PLANT BARRY COAL ASH POND HYDROGEOLOGIC CONDITIONS SUMMARY

Marlon Cook

Manager: Cook Hydrogeology LLC

January 2018
Potentiometric Surface Map

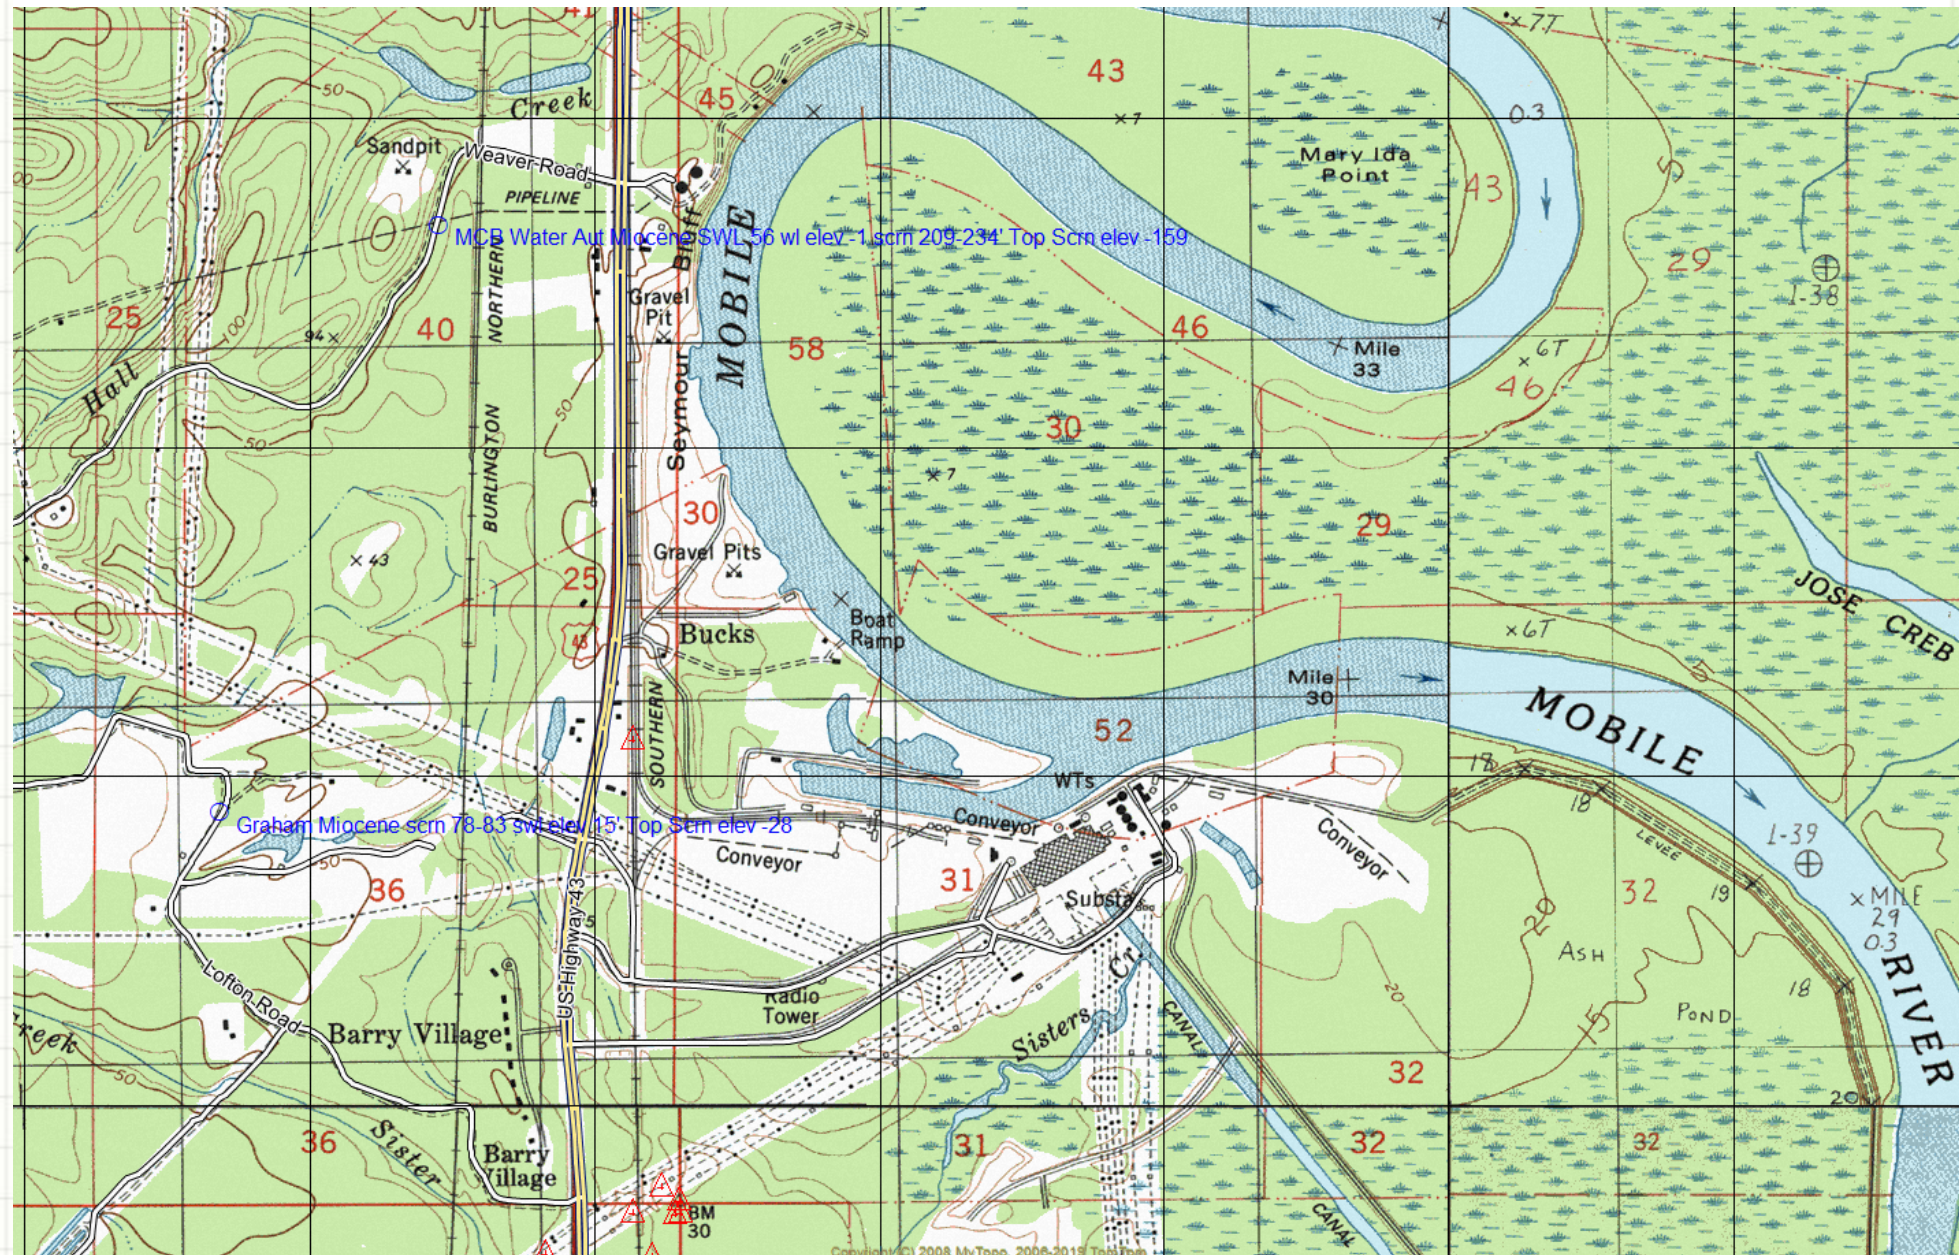
What is the direction of groundwater flow in the Plant Barry area and what impact does the Mobile River have on groundwater flow?

If contaminants get into the alluvial aquifer, where will they go and is there any possibility that contaminants will move into the Miocene aquifer?

All regional groundwater flow (Alluvial and upper Miocene aquifers) in the Plant Barry/Bucks area is eastward to the Mobile River.

The hydraulic gradient in the alluvial aquifer in the ash pond area is 0.0003, which is extremely flat, meaning that groundwater movement is slow. Groundwater flow velocity calculated for the site is 2.92 feet per year towards the Mobile River.

Contaminants in the alluvial aquifer will eventually flow into the Mobile River.

The Mobile River at Plant Barry

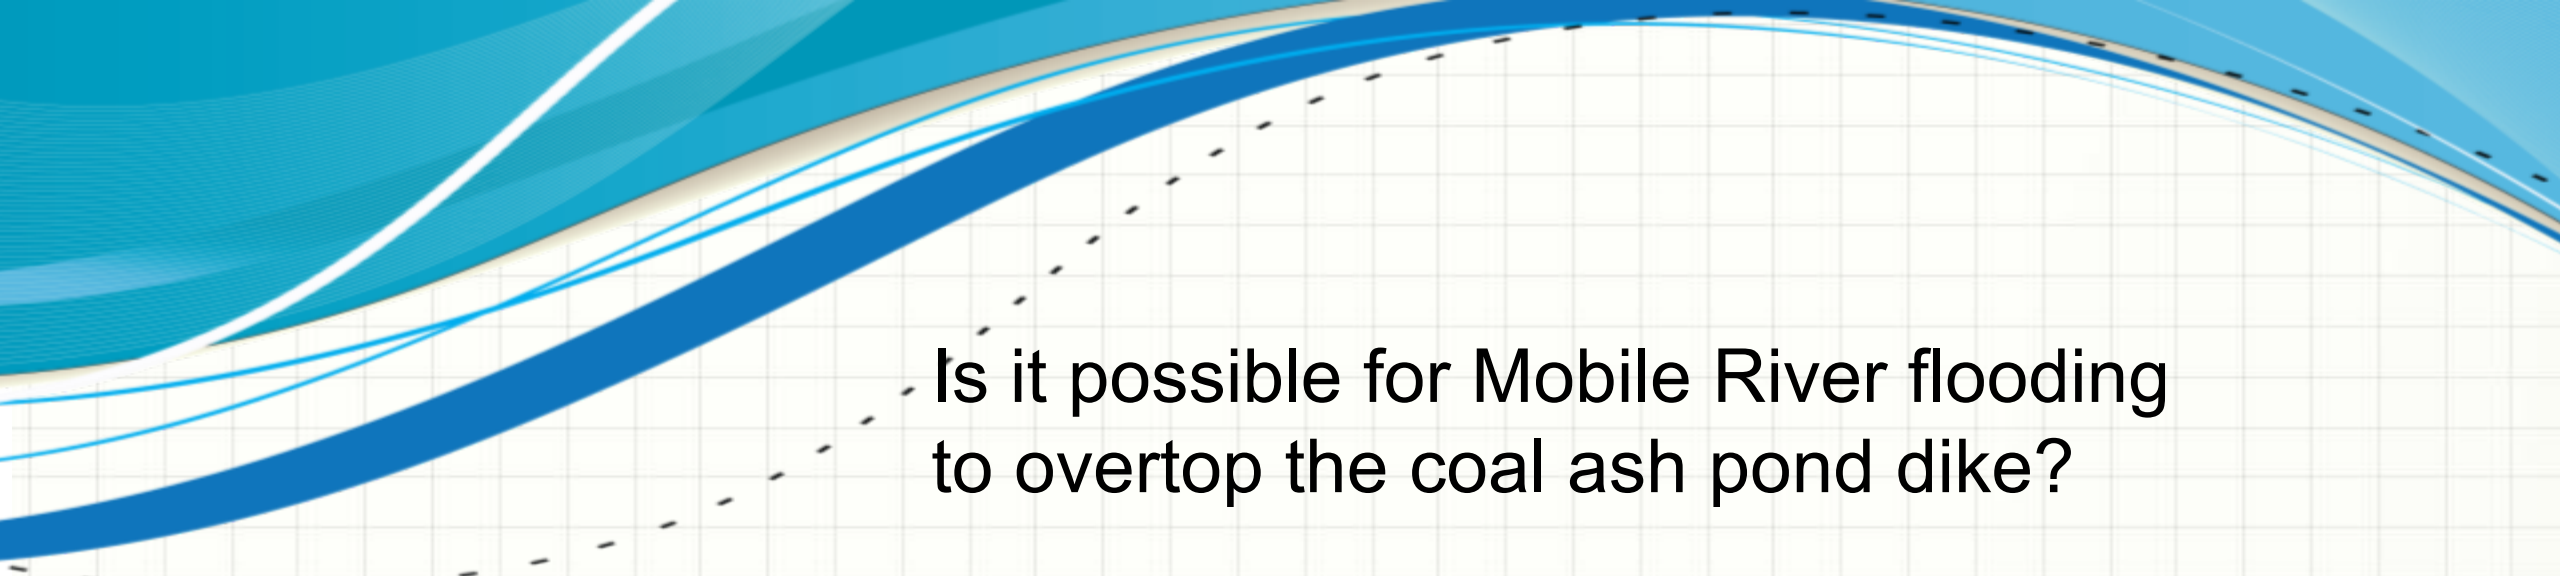
What is the potential for the Mobile River channel to relocate through Plant Barry and the coal ash pond?

What is the potential for the Mobile River channel to relocate through Plant Barry and the coal ash pond?

Conclusion: The potential for a meander cut-off at Plant Barry is not realistic. The ash pond is located on a point bar. Therefore, the channel is migrating eastward away from the facility.

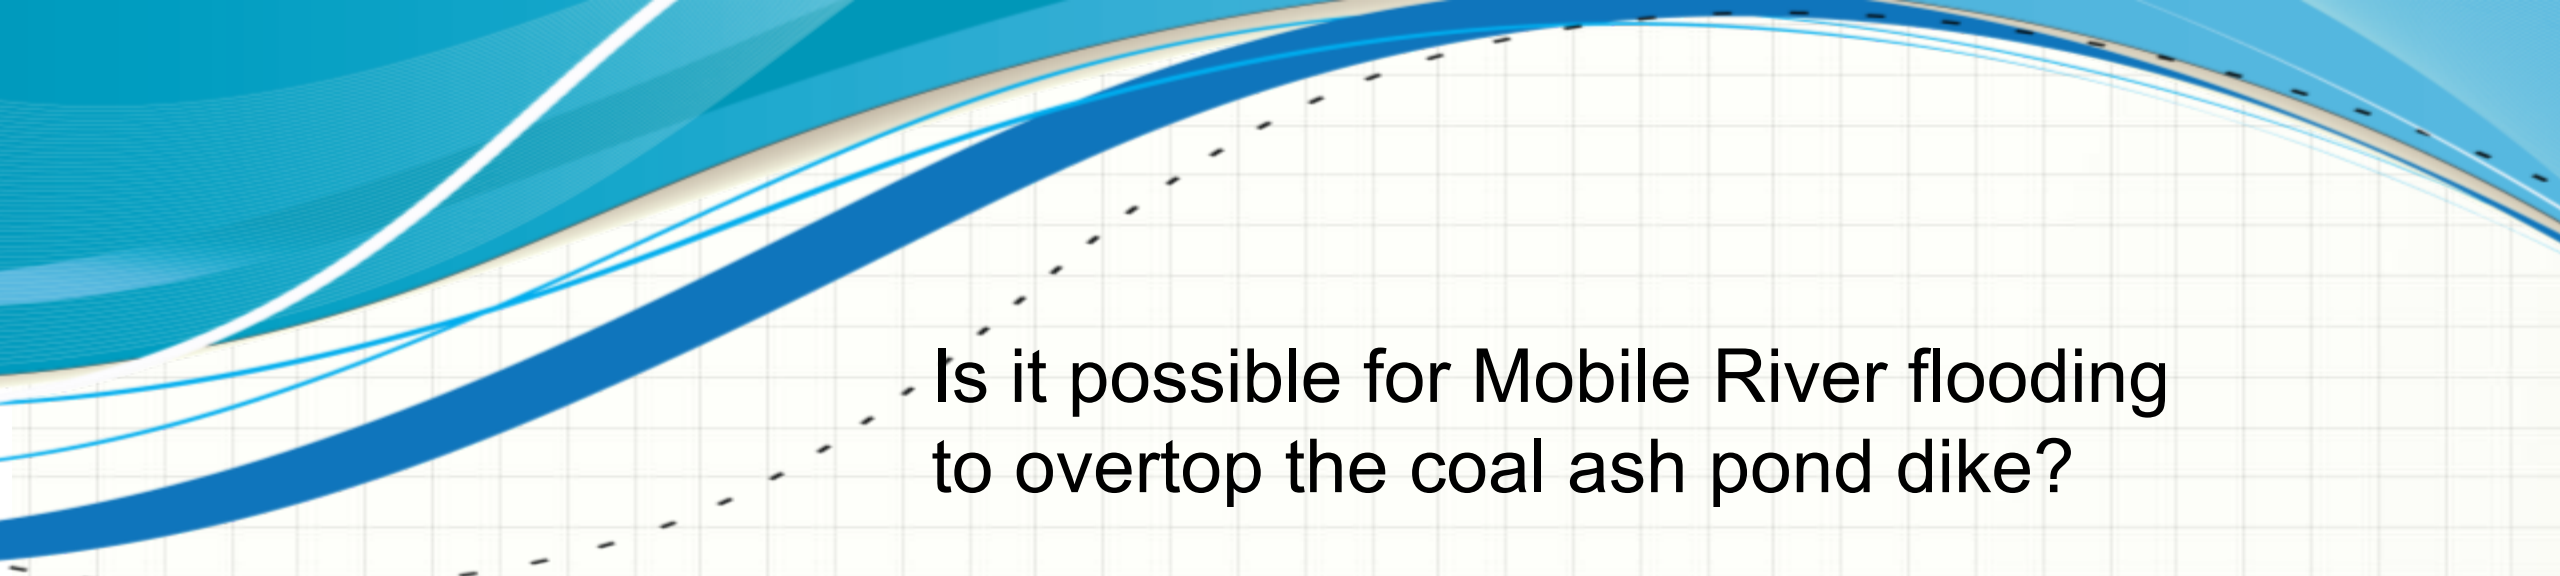
Is it possible for Mobile River flooding to overtop the coal ash pond dike?

Combinations of future climate factors, including rising sea level, a major upstream flood, and a severe tropical storm could cause a catastrophic flood event on the Mobile River that could inundate the coal ash pond.

Is it possible for Mobile River flooding to overtop the coal ash pond dike?

Conclusion: A catastrophic level flood event on the Mobile River at the coal ash pond site has not been simulated. Whether the coal ash is excavated and relocated or capped in place, the impacts of a flood of this magnitude during the next 20 to 30 years should be considered and impacts on an encapsulation structure for an indefinite time period should be a part of an in-place closure plan.

Cook Hydrogeology and the MBNEP Science Advisory Committee has recommended to Alabama Power that simulations of various major flood scenarios is warranted.
